PCI-SIG ENGINEERING CHANGE NOTICE

TITLE:	MMCONFIG ECN for PCI Express
DATE:	February 17, 2004
AFFECTED DOCUMENTS:	PCI Express Base Specification 1.0a PCI Express Root Complex Topology Discovery ECN
SPONSOR:	Dong Wei & Joe Cowan; Hewlett-Packard Company

Figure 7-62 Link Address for Link Type 1

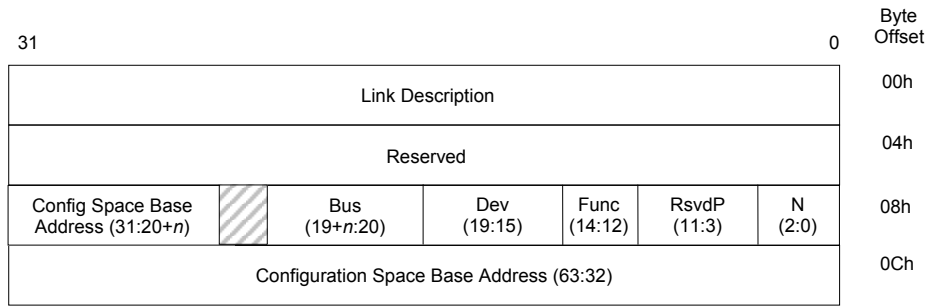
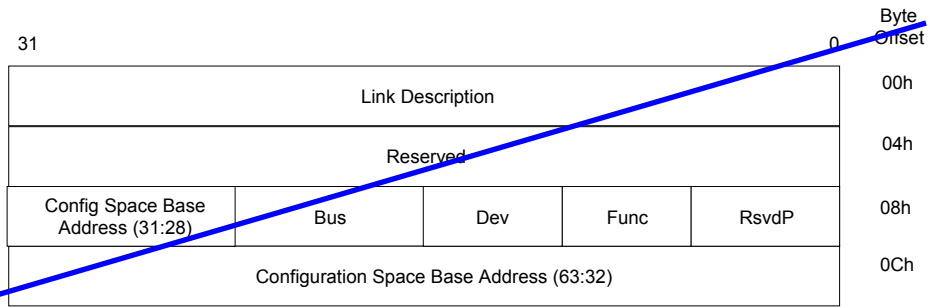
Change Section 7.13.3.2.2, page 10 as follows:

7.13.3.2.2 Link Address for Link Type 1

~~For a link pointing to the configuration space of a Root Complex element (Link Type = 1), Bits 27:12 of the first DWORD specify the bus, device and function number of the configuration space of the target element as shown in the table below; bits 11:0 are reserved and hardwired to 0.~~ For a link pointing to the configuration space of a Root Complex element (Link Type = 1), bits in the first DWORD specify the bus, device, and function number of the target element. As shown in Figure 7-62, bits 2:0 (N) encode the number of bits n associated with the bus number, with $N=000b$ specifying $n=8$ and all other encodings specifying $n=<value\ of\ N>$. Bits 11:3 are reserved and hardwired to 0. Bits 14:12 specify the function number, and bits 19:15 specify the device number. Bits $(19+n):20$ specify the bus number, with $1 \leq n \leq 8$.

Bits 31: ~~$(20+n)$~~ ²⁸ of the first DWORD together with the second DWORD optionally identify the target element's hierarchy ~~(for multi-hierarchy systems~~ implementing the PCI Express Enhanced Configuration Access Mechanism) by specifying bits 63: ~~$(20+n)$~~ ²⁸ of the memory-mapped configuration space base address of the PCI Express hierarchy associated with the targeted element; single hierarchy systems that do not implement more than one memory mapped configuration space are allowed to report a value of 0 to indicate default configuration space.

A configuration space base address [63: ~~$(20+n)$~~ ²⁸] equal to zero indicates that the configuration space address defined by bits [~~$(19+n)$~~ ²⁷:12] (bus, device number, and function number) exists in the default configuration space segment; any non-zero value indicates a separate configuration space base address.

Software must not use n outside the context of evaluating the bus number and memory-mapped configuration space base address for this specific target element. In particular, n does not necessarily indicate the maximum bus number supported by the associated configuration space segment.
